Staff Report

Date: March 28, 2022

To: Conservation Commission

Subject: **748 Sconticut Neck Road – Request for Certificate of Compliance – DEP# 023-0725, Fairhaven CON 023-204**

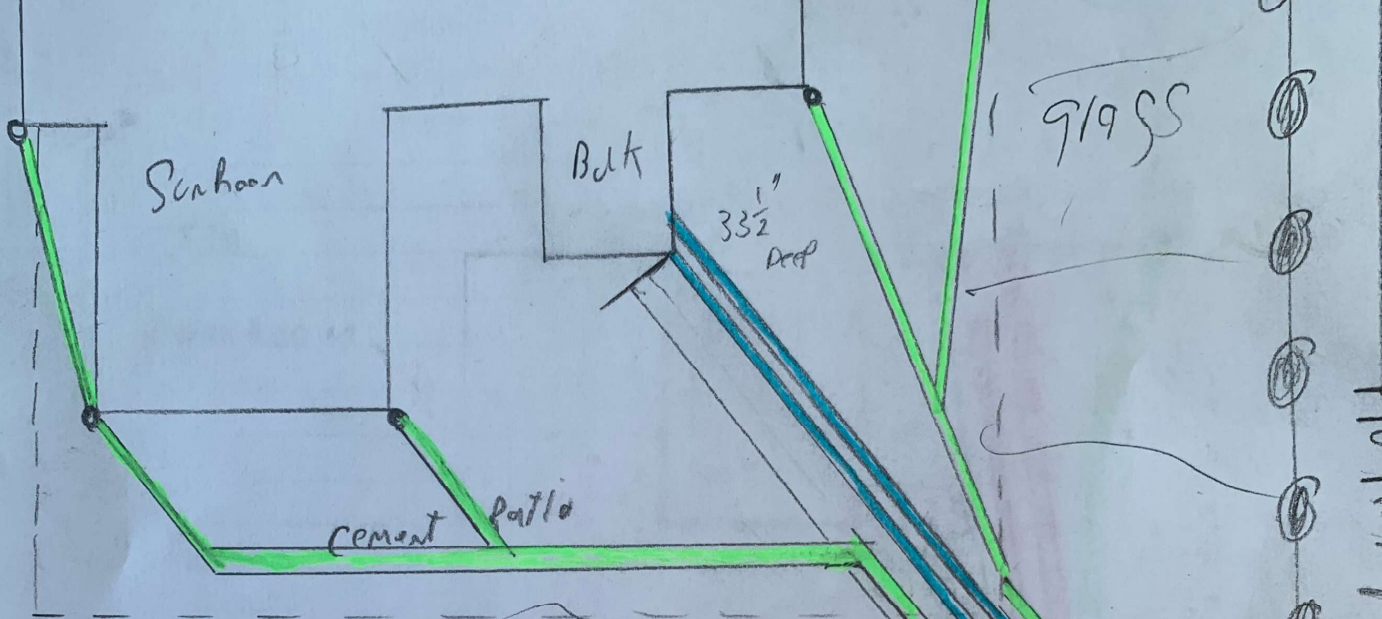
FLOOD NOTE:
 THE PROPERTY DEPICTED ON THIS PLAN FALLS IN ZONE "AE (EL 14 FEET)", AS SHOWN ON THE FLOOD INSURANCE RATE MAP25005C0502F, EFFECTIVE DATE JULY 7, 2009.
